Accessibility Survey

City of Downey Dollison Avenue - Studebaker Road to End

Date of Inspection
2/8/2017

Prepared By
Disability Access Consultants
(800) 743-7067

Bush East of Studebaker Avenue @ 33.935334623747, -118.097642809153

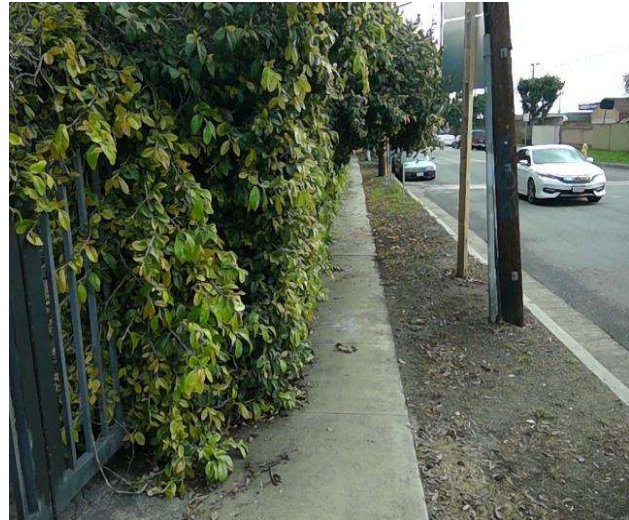
Sidewalks , Hazards & Gratings : Sidewalk Width at Obstruction

Sidewalk width at the obstruction is not compliant.

On-Site Finding 24.00 inches

Sidewalk width at the obstruction shall have the recommended value.

Recommendation At least 48.00 inches
